From: Hailey Sheldon <hailey@sheldonplanning.com>
Sent: Thursday, June 1, 2023 12:29 PM
To: Clare Kurth; Wendy Farley-Campbell
Subject: Fwd: Myrtle Glen Questions
Attachments: Tentative Sheet_2 02222023 with comments.pdf; Tentative Sheet_2 02222023 with comments.pdf

From: Clare Kurth <clare.kurth@ci.florence.or.us>
Subject: Myrtle Glen Questions
Date: June 1, 2023 at 9:35:34 AM PDT
To: "hailey@sheldonplanning.com" <hailey@sheldonplanning.com>
Cc: Wendy Farley-Campbell <wendy.farleycampbell@ci.florence.or.us>

**MYRTLE GLENN PUD
 TENTATIVE PLAN
 STREET AND UTILITY PLAN
 FLORENCE, LANE COUNTY, OREGON**

TENTATIVE STREET AND UTILITY PLAN

Sheet Number
SHEET 2

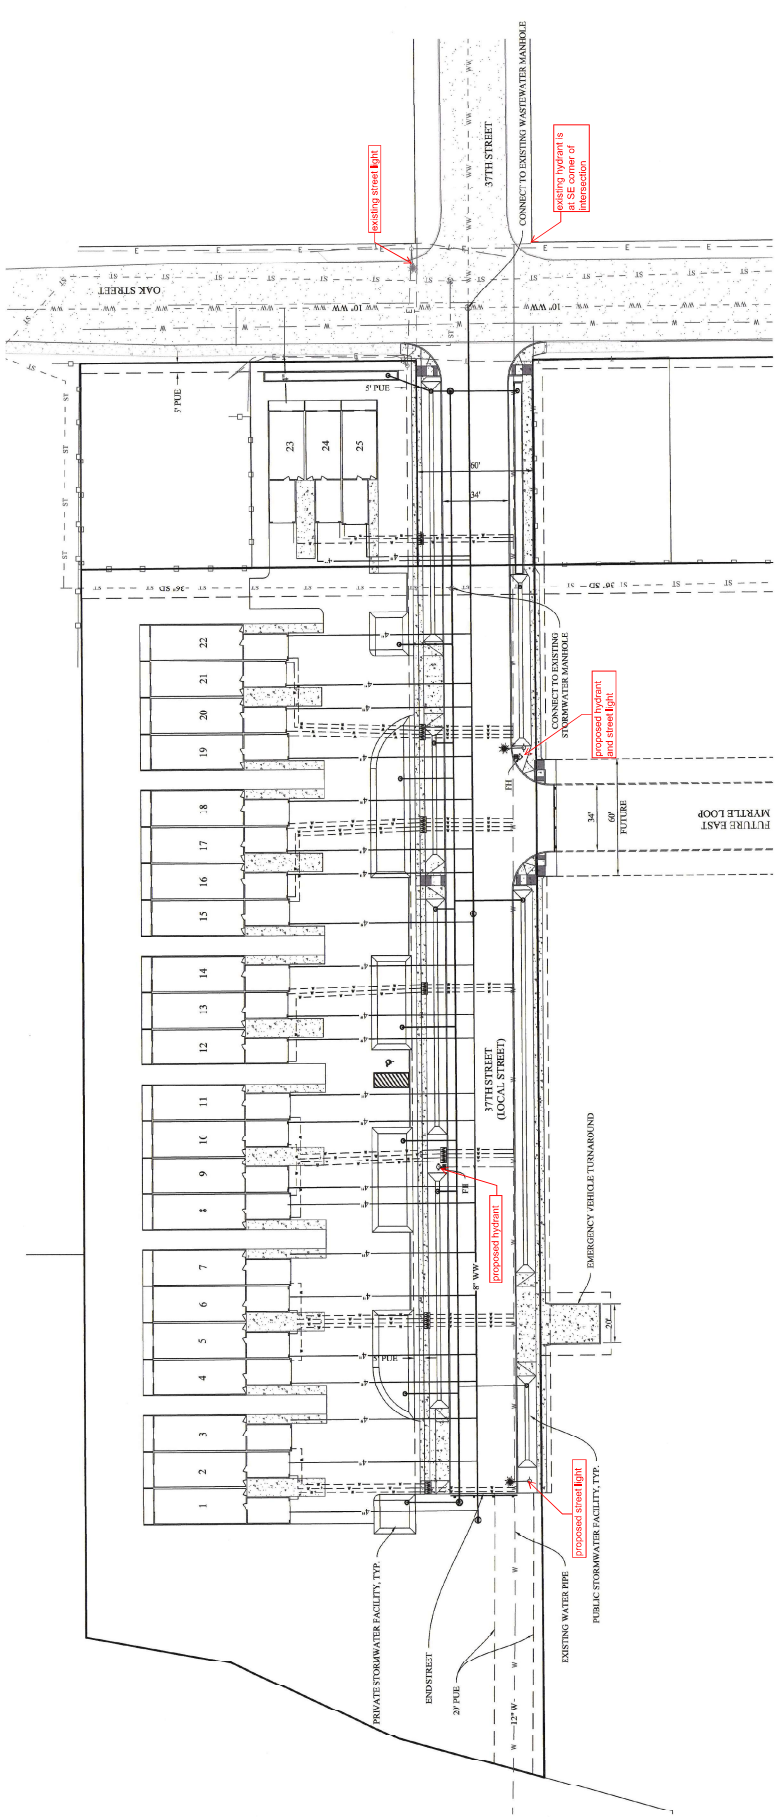
- How many street lights are proposed and specifics of these street lights?
- Fire Hydrants? Where and how many?
 - If I just missed them on the attachment let me know where to look
- Rear porch/yard?
 - What are the materials for the porch?
 - Is this included in the impervious surface calculations?
 - Will there be a privacy wall between units like Oak Commons has?
 - Will the master bedroom have a deck like Oak Commons?
- How tall will these buildings be from average grade to roof peak?
 - Fire Chief Schick mentioned there may be a need for access for an aerial apparatus if over 30 feet.
- Will these units have automatic sprinklers?

- Street lights and fire hydrants - 2 street lights; see attached Sheet 2 with highlighted hydrant and light locations. Street lights will be per city standards. *It looks like the 3/17 application is missing plan sheets 2 and 5! Here is a [link to the full plan set](#), which includes all 5 sheets. I apologize for the oversight and the inconvenience. I bet Sheet 2 will clear a few things up.

See attached Sheet 2 with highlighted hydrant and light locations. Two hydrants and two street lights are proposed. Street lights will be per city standards.
